Land South East of 18 Midford Lane, Limpley Stoke
Discharge of condition 8 of PL/2023/10970 (Drainage)

In response to the Wiltshire Council drainage consultation letter dated 24th February 2026, providing comment on condition 8 (Drainage), we provide the following response to each condition item raised.

Drawing ref. M2-2801-SK-602 P4	SW Drainage Layout
Drawing ref. M2-2801-SK-605 P2	Drainage Construction Details
Surface Water SuDS Calculations

DRAWING TITLE:
Surface Water Drainage Layout

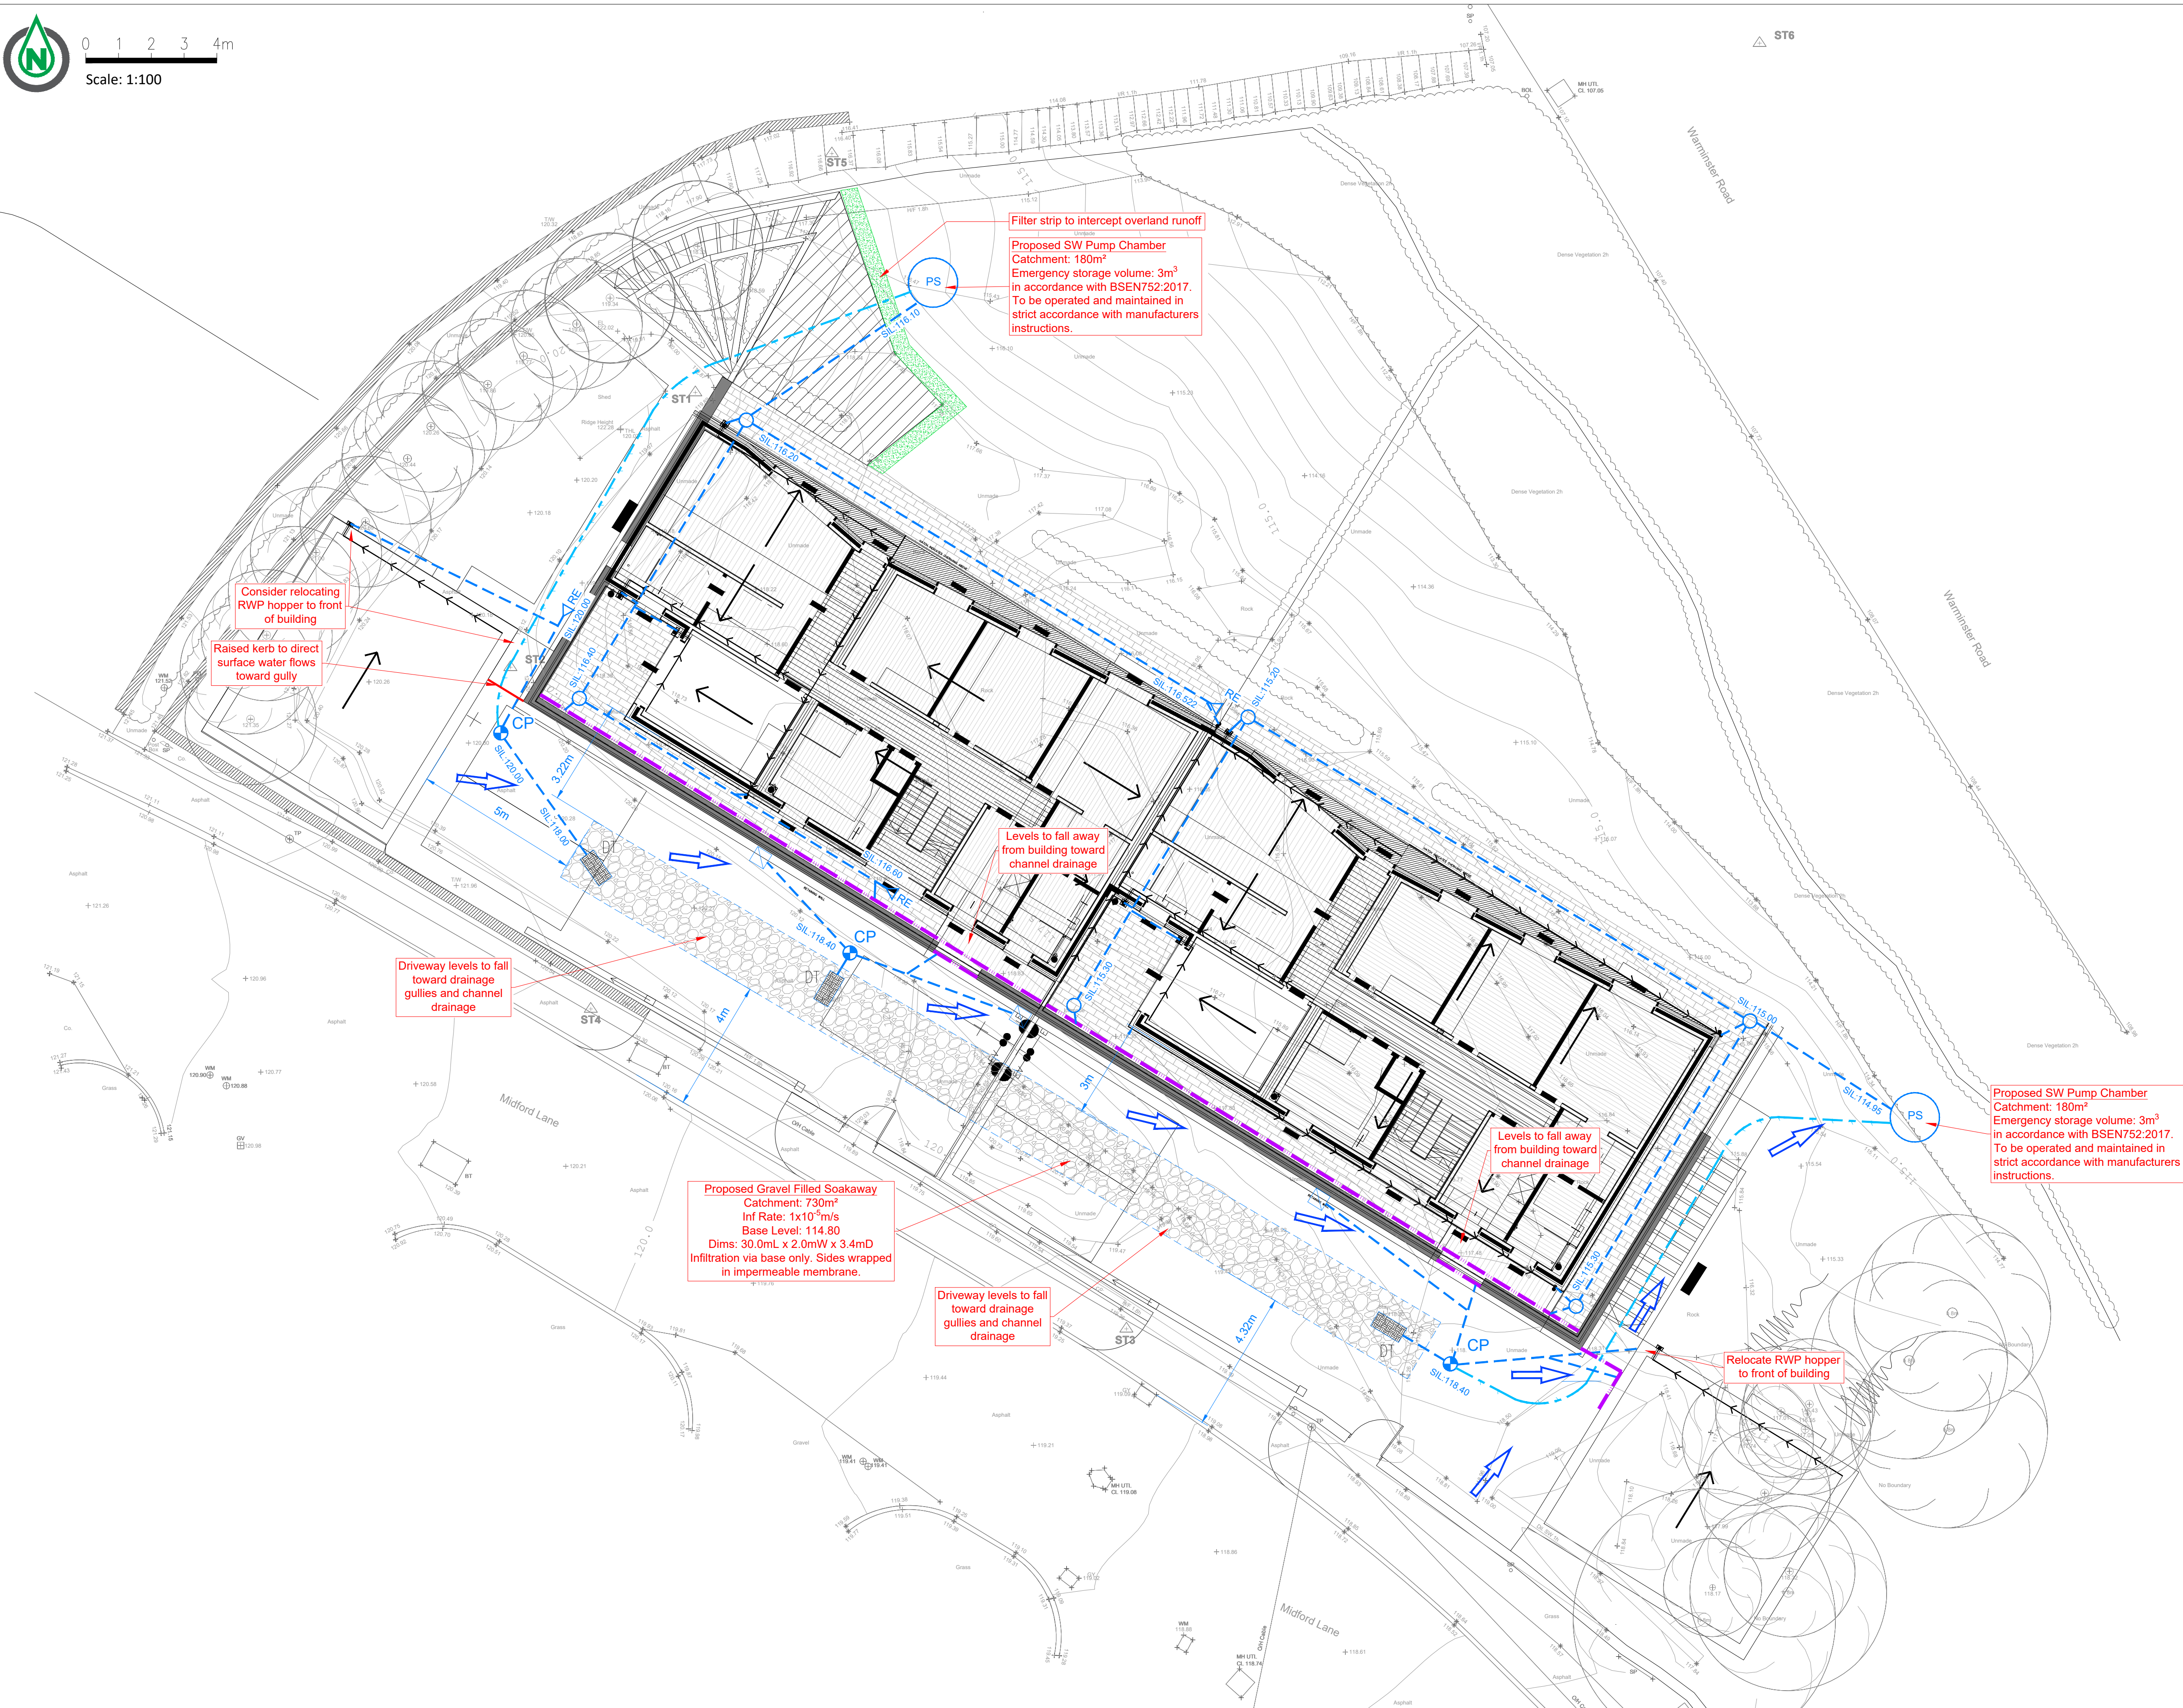
“The applicant must provide calculations related to the surface water drainage strategy:

- The 1 in 30 year rainfall event is contained within the drainage system without causing flooding to any part of the site.*
- The 1 in 100 year plus climate change rainfall event does not cause flooding to any building (including a basement) or utility plant.*
- The site has been designed to ensure that flows in excess of the 1 in 100 year rainfall event are managed in exceedance routes that minimise the risks to people and property.*
- Calculations which demonstrate that the proposed drainage design provides a sufficient level of water treatment.”*

- The applicant must justify why there is no filter strip proposed in the northeast of the site. Observing the overland flow routes, it appears flow may be directed offsite towards Warminster Road.”*

Refer to the enclosed Infodrainage calculations and surface water drainage layout.

Both the 30yr event and 100yr+45% climate change events are contained wholly within drainage system and soakaway.

Overland flow routes are directed around the properties to lower level open green spaces.

There is no bank to intercept, other than the existing bank arrangement. Everything upstream of this is contained within the new drainage system.

CATCH PIT / DISTRIBUTION TANK OUTLET AND FILTER TRENCH SECTION

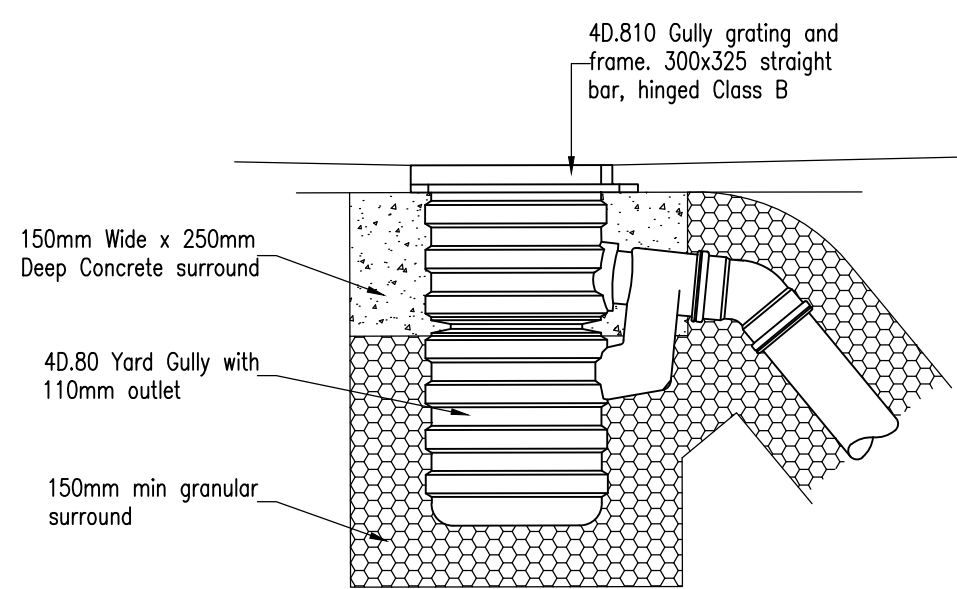
“The applicant has proposed a filter strip in the north west of the site to intercept overland flow:

- The applicant must provide standard sections of this feature, detailing whether the filter strip is connected to the surface water drainage network, or permeably lined.”*

Refer to the enclosed drainage construction details. The filter strip is not connected to the drainage network and is self draining.
